## MEMORANDUM

To: Development Review Board  
From: Mary O'Neil, AICP, Principal Planner  
Date: March 21, 2017  
RE: ZP17-0762CA/CU; 35 Grove Street

**File:** ZP17-0762CA/CU  
**Location:** 35 Grove Street  
**Zone:** RL **Ward:** 1E  
**Date application accepted:** February 3, 2017  
**Revised plans received:** March 13, 2017  
**Applicant/ Owner:** Gina Lambdin  
**Request:** Addition to existing single family dwelling, demolish garage, construct detached accessory dwelling unit, reconfigure parking area.

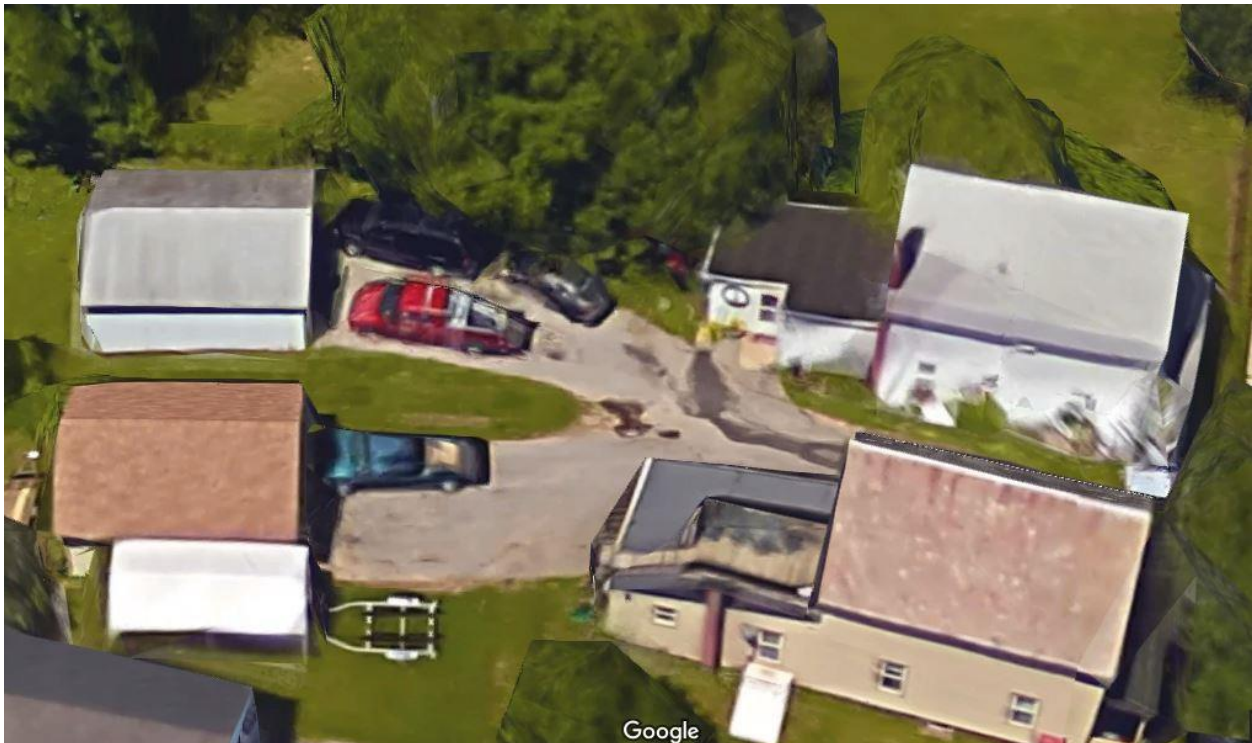
2. *The unit does not consist of more than 30 percent of the total habitable floor area of the building, inclusive of the accessory dwelling unit;*

Utilizing the definition of habitable space from Article 13, the ADU does not exceed 30% of the total habitable floor area of the principle dwelling and the ADU combined. **Affirmative finding.**
